## **Appendix A**

### **Review of Public Comments Received by the TWDB**

The United States Geological Survey, in cooperation with the Texas Water Development Board, has completed a groundwater availability model for the northern portion of the Gulf Coast Aquifer System (Ellis and others, 2023). This model meets TWDB modeling, public comment, and stakeholder involvement standards. Therefore, this model is now the current groundwater availability model for the northern portion of the Gulf Coast Aquifer System. This appendix is ancillary to the model report, and contains the public comments received and responses to those comments. The model report can be found at <https://pubs.usgs.gov/publication/pp1877> or [https://www.twdb.texas.gov/groundwater/models/gam/glfc\\_n/glfc\\_n.asp](https://www.twdb.texas.gov/groundwater/models/gam/glfc_n/glfc_n.asp).

### Lone Star Groundwater Conservation District (LSGCD)

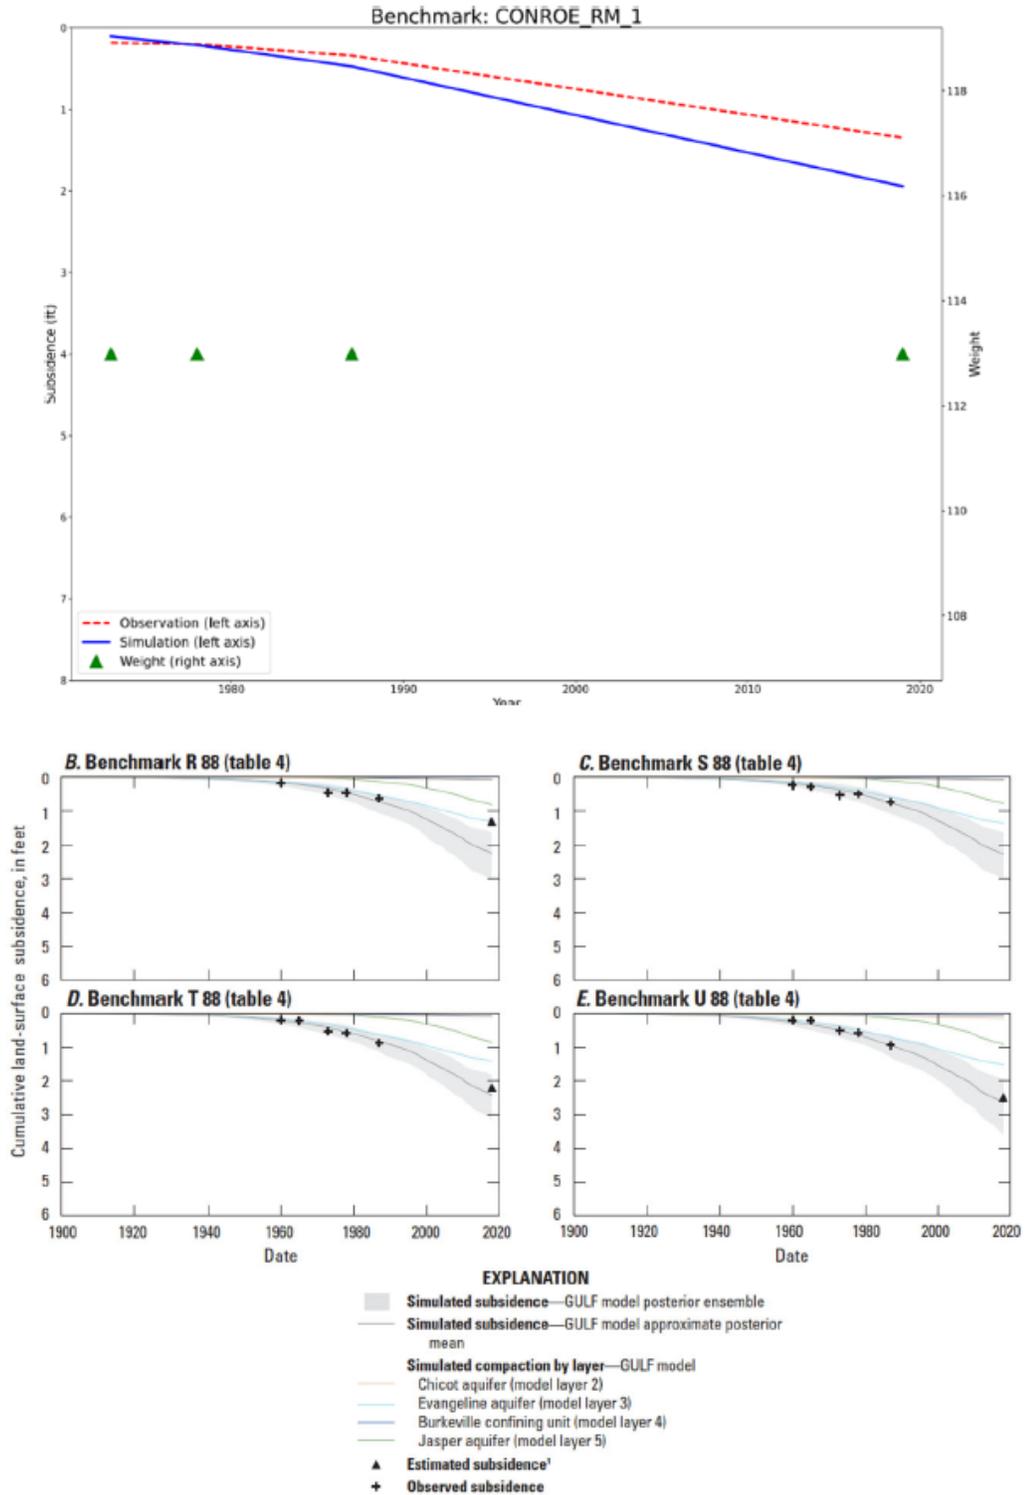
19. [comment 21] “Most of the simulated subsidence at benchmarks in Harris County and Montgomery County match well with the observed subsidence. A few of the benchmarks have a good match with early data in the 1900s but not the recent years (see the following figures). The posterior ensemble (see the following figures; Figure 172-174 from Ellis and others (2023)) shows that the uncertainty of simulated subsidence at benchmarks is getting larger as years pass, which also appears at the simulated vertical displacement at GPS stations and subsidence at extensometers. What is the reliability of predicted subsidence by the Gulf 23 for Harris County and Montgomery County?”

Response: As stated in the GULF report “Model Uses, Limitations, and Assumptions” section, “A limitation of any forecast model is that the further out the model forecasts, the greater the uncertainty.”

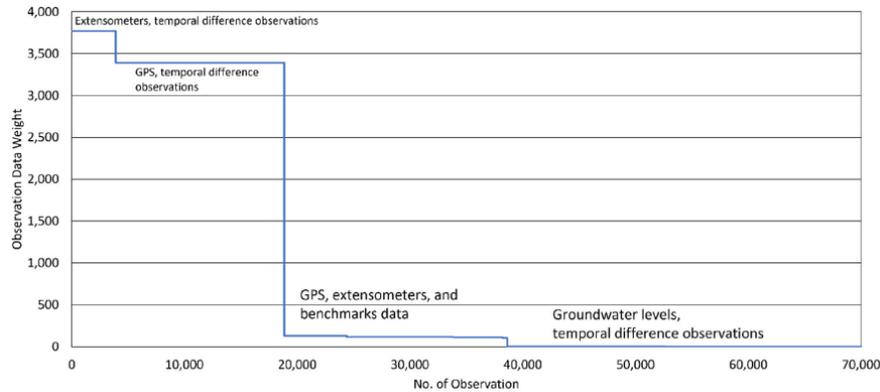
21. [comment 23] “71,929 observations of subsidence and water level data were used to calibrate the Gulf23 model and each calibration data point has one weight that can be found in the spreadsheet “gulf\_history.obs\_data.csv”. The weights of each type of observation data are plotted in the following figure. The temporal difference observations at extensometers and GPS stations have the highest weights compared to the other subsidence and water level data. We assume that the weighting differences are to ensure reasonable objective function. Can the authors comment on how the difference in weighting outside of the greater Houston area influences the simulation of water levels and subsidence outside of Harris County and the greater Houston area?”

*Response: The weighting was adjusted across the model area during calibration to provide the best fit to the water level observations and the subsidence dataset. The group contribution to the objective function shown in GULF table 7.1 generally represents the number of observations in each observation group relative to the other groups and also reflects the confidence in the data. For example, all the annually measured sites (which are in the greater Houston area) are included in the “groundwater levels” group with a weighting of 20 percent. Because these sites are measured annually, there is greater confidence in these water level measurements than in the wells in the “groundwater levels, general” observation group containing wells with single measurements. Had the observations been equally weighted, the smaller number of observations outside the greater Houston area would have had an outsized impact on the calibration process.*

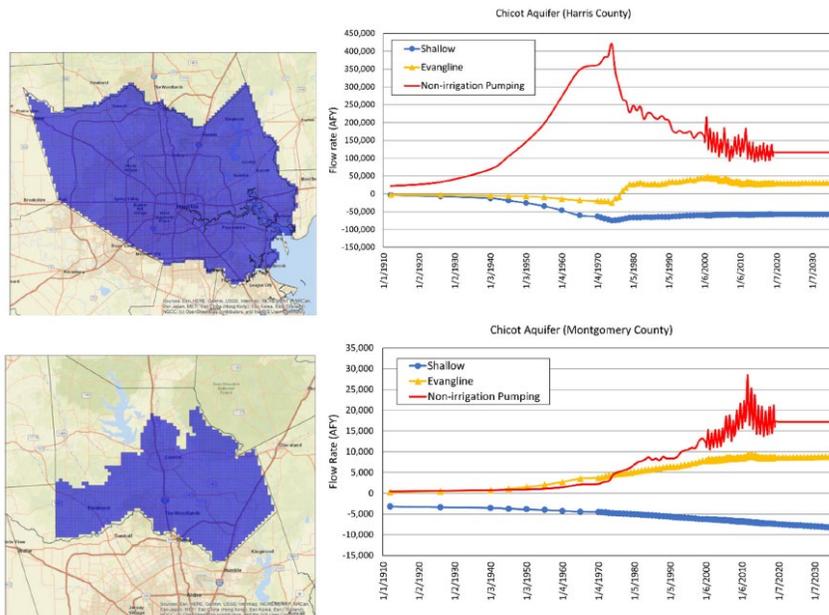
23. [comment 25] “Zone files for Harris County and Montgomery County are included in the Gulf23 model files, but no zone budget analysis was conducted and documented. The zone files were used to run a zone budget analysis to plot vertical leakage with respect to pumpage for Chicot Aquifer and Evangeline Aquifer in Harris and Montgomery Counties.

The following figures on the left are the zone files and the figures on the right are flow hydrographs. The Chicot Aquifer in Harris County receives discharges from the shallow groundwater system and upward discharges from the Evangeline Aquifer during predevelopment conditions. The upward leakage increased as the pumpage was higher when predevelopment conditions transitioned to developed conditions. In regulation and post-developed conditions, the hydraulic gradient was reversed and downward leakage was created from Chicot Aquifer to Evangeline Aquifer.

The Chicot Aquifer in Montgomery County receives discharges from the shallow groundwater system while providing recharge to the Evangeline Aquifer and water sources for pumping. Water budget components like vertical leakage and storage related to aquifer compaction and groundwater use should be further discussed for Harris County and Montgomery County.”

*Response: Detailed discussion on water budget components on a per county basis is outside the scope of a regional scale numerical groundwater availability model report.*
